South Texas Project
Units 3 and 4
Docket Nos. 52-012 and 52-013
Response to Requests for Additional Information

Attached are Nuclear Innovation North America LLC (NINA) responses to staff questions in Request for Additional Information (RAI) letter number 415 and a revised response related to Combined License Application (COLA) Part 2, Tier 2, Section 9.1, "Fuel Storage and Handling." The attachments to this letter include non-proprietary responses (Attachments 1, 2 and 3) and proprietary responses (Attachments 5, 6 and 7) to the following RAIs:

RAI 09.01.02-9

RAI 09.01.02-17**QUESTION:**

Figure 1 Comparison of Input vs. Calculated Response Spectra, Horizontal (X)

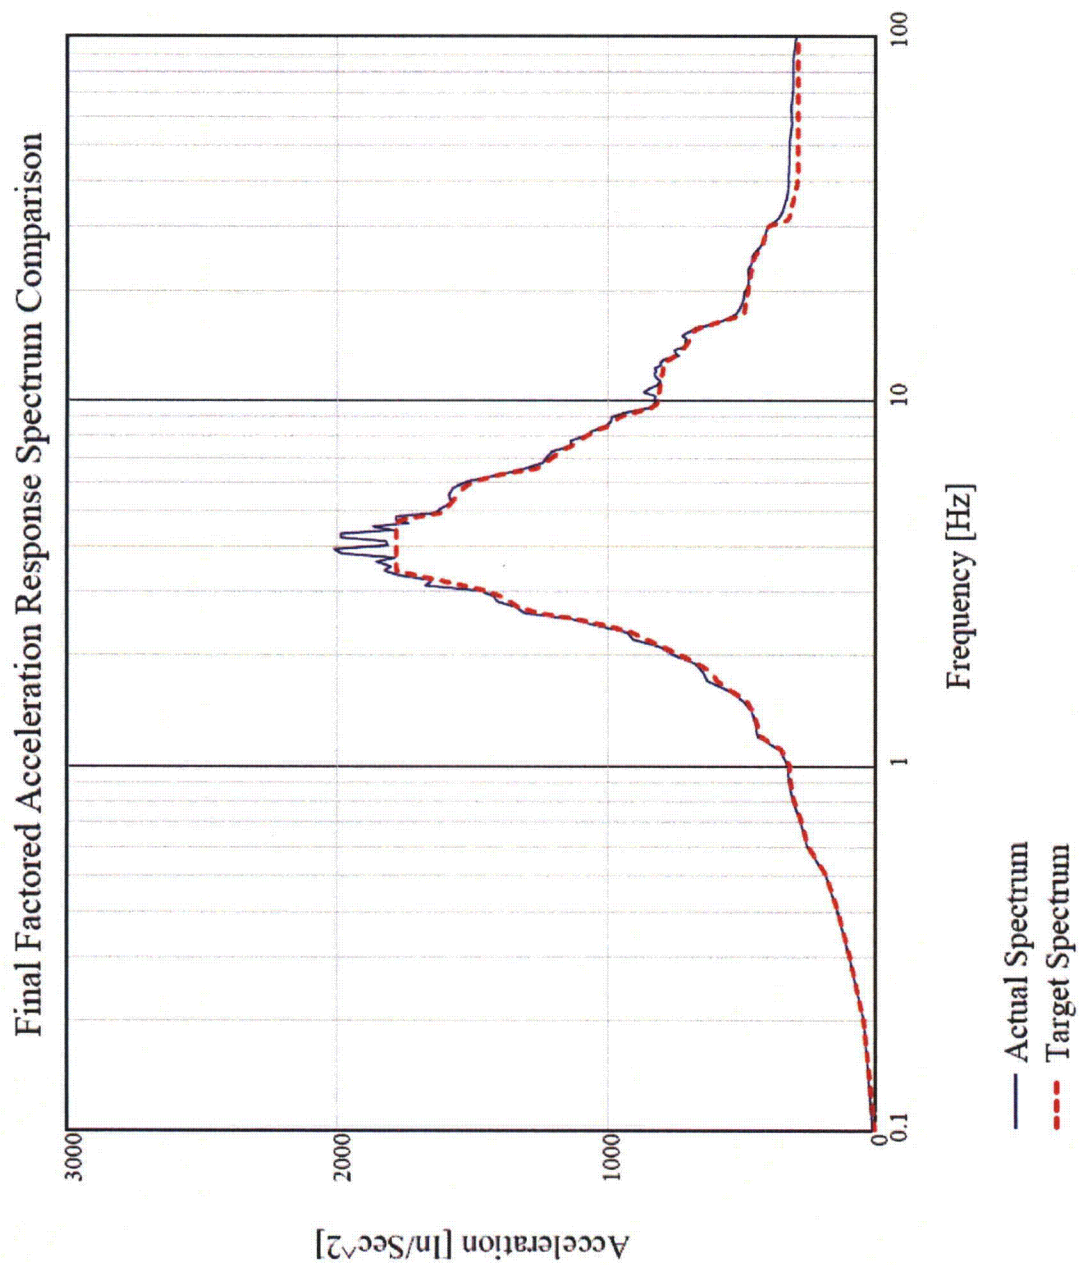
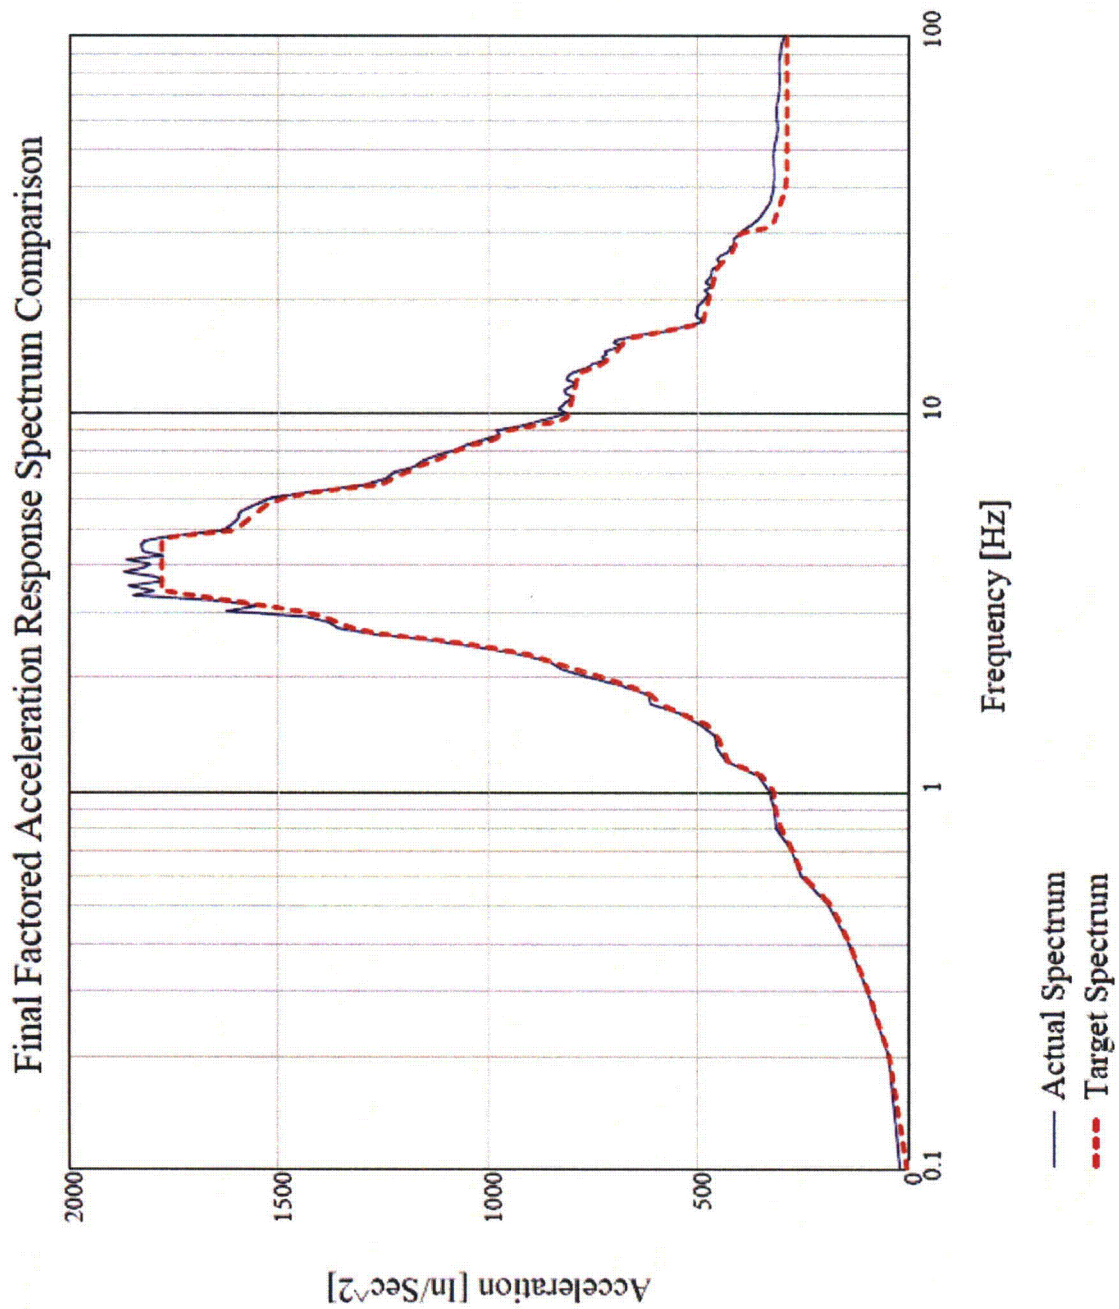
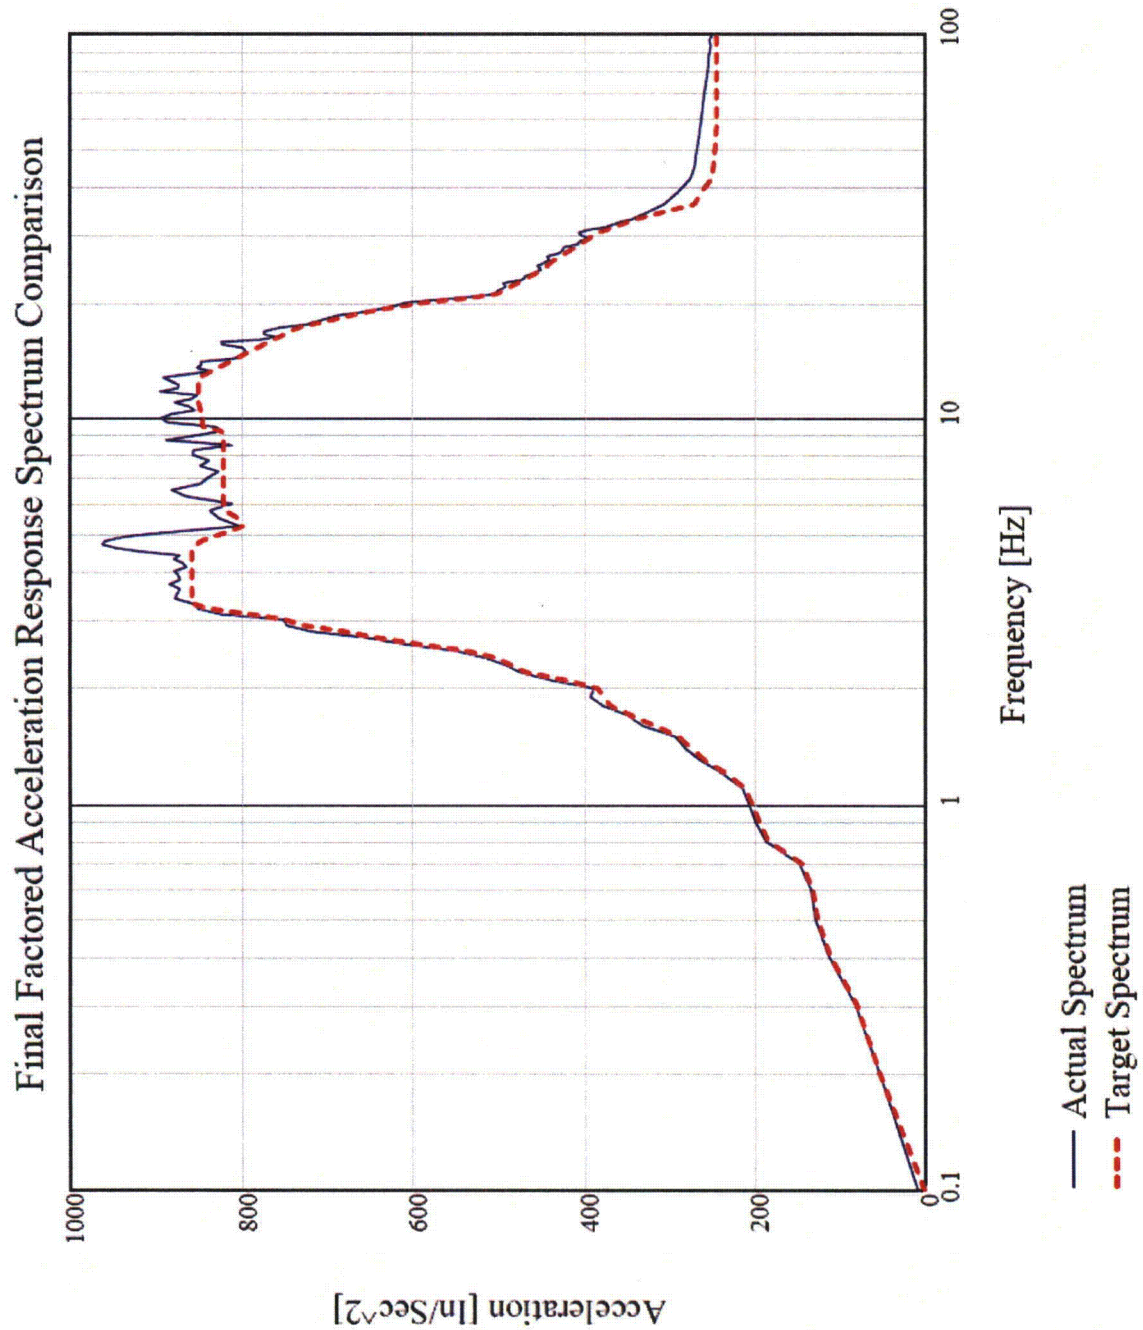
- a. Confirm that the 3 synthetic time histories have been checked against each other to ensure statistical independence. Compare the calculated correlation coefficients to the acceptance criterion of ≤ 0.16 . Include this information in the spent fuel racks technical report.
- b. Provide figures comparing the 5% damped spectra (2 horizontal, vertical) generated from the synthetic time histories to the 5% damped target spectra (horizontal, vertical) at node 100. Identify the criteria used to verify the adequacy of the match. Include this information in the spent fuel racks technical report.

- b. The following figures show the comparison of the 4% damped spectra (2 horizontal, vertical) generated from the synthetic time histories to the 4% damped target spectra (horizontal, vertical) at node 100. Per the requirements of NUREG-0800, Standard Review Plan 3.7.1, the SRP Acceptance Criteria on page 10 states that "Each calculated spectrum of the artificial time history is considered to envelop the design response spectrum when no more than five points fall below, and no more than 10 percent below, the design response spectrum." Synthetic time histories were created for 4% damping at Node 100, per the requirements of Reg Guide 1.61, "Damping Values For Seismic Design Of Nuclear Power Plants," as required for welded steel or bolted steel structural material with friction connections (RG 1.61, Table 1, "SSE Damping Values"), not the 5% as requested above.

The following table shows compliance to the NUREG-0800, Standard Review Plan Section 3.7.1 for Response Spectra Comparison (the number of points below the target is less than or equal to 5, and the maximum percent under the target is less than 10%):

Figures 1, 2, and 3 show that the synthetic generated time histories envelop the target response spectra using 4% damping at Node 100 for all three directions. A statement summarizing that the synthetic time histories are developed using the guidance of, and meet the validation criteria of, SRP Section 3.7.1 will be included in the next revision of the spent fuel racks Technical Report.

Figure 4 Actual Raw and Average PSD vs. Target – Horizontal (X)

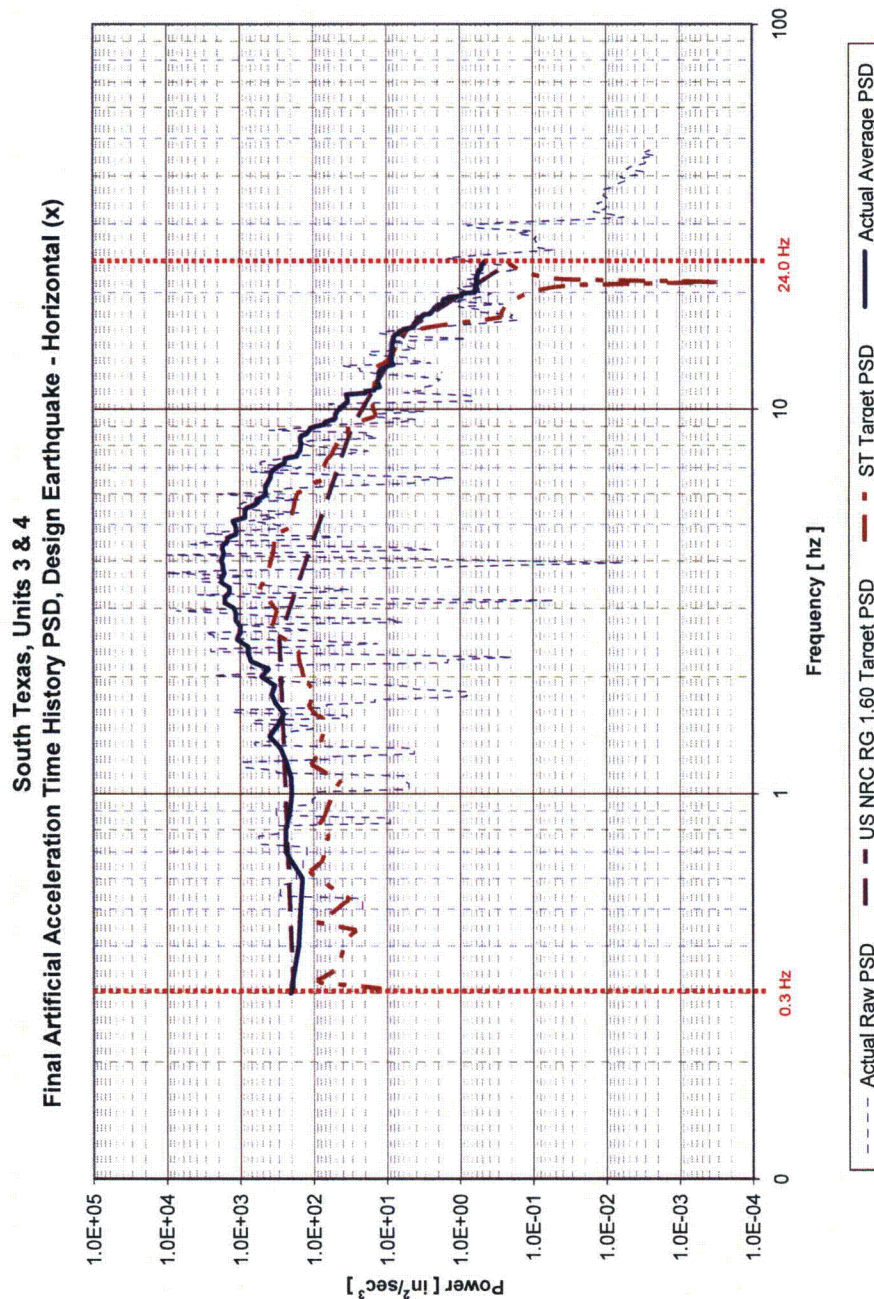
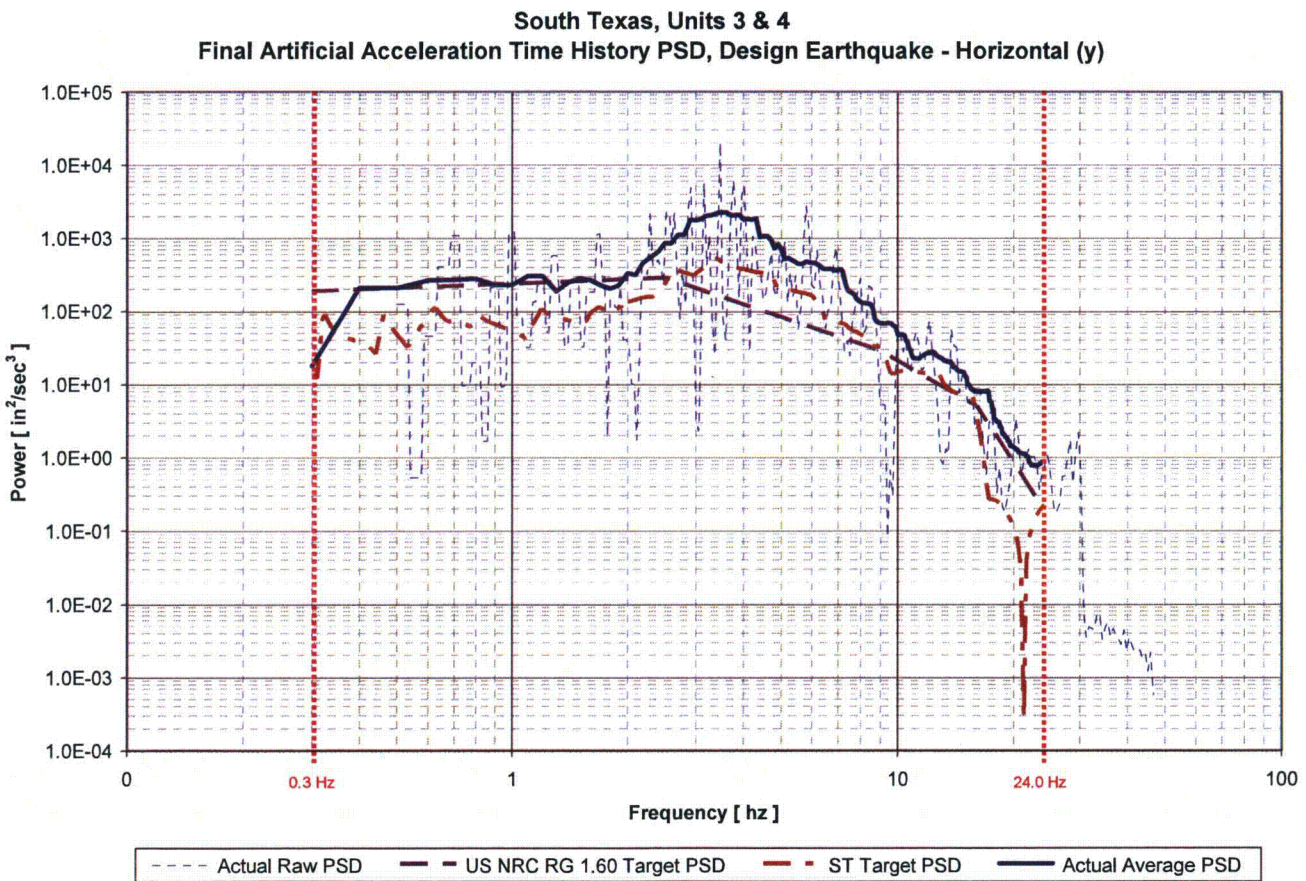
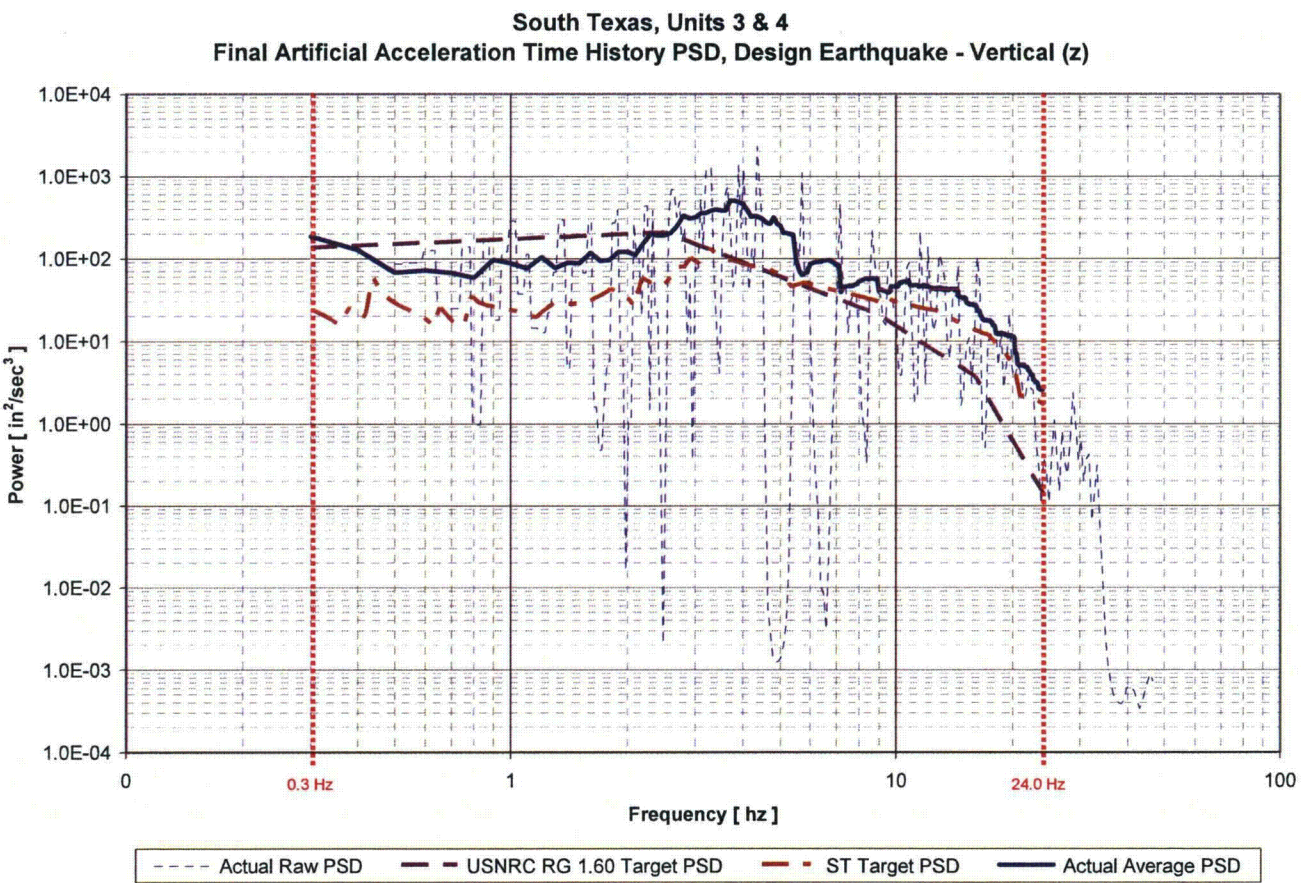
- c. Describe how target PSDs were developed for the Node 100 target spectra, and provide figures comparing the PSDs for the synthetic time histories to the PSDs for the target spectra. Identify the criteria used to verify the adequacy of the PSDs for the synthetic time histories.

Figures 4, 5, and 6 are plots of the 80% NRC target PSD function, the actual raw PSD, the actual average PSD, and the site-specific target PSD function for each case.

It can be seen that the actual average PSD curves are above the STP-specific target PSD curves with exceptions as follows:

- X direction, around 15Hz, the actual average is approximately equal to the target.
- Y direction, around 0.32 Hz, the actual average is below the target.

The PSD check that is required by SRP Section 3.7.1 is for synthetic motion generated at the ground level. Because the STP 3&4 synthetic motion is at a higher elevation within containment, the PSD check has been conservatively applied at the higher elevation. There

are two small frequency ranges (between 0.3-0.4 Hz in the horizontal “Y” direction and between 10-20 Hz in the horizontal “X” direction) where the actual PSD is below the site specific target PSD. The actual PSD is very close to the target PSD within these frequency ranges, and because the input response spectra is at an elevation above ground level, the artificial time history data is deemed acceptable.
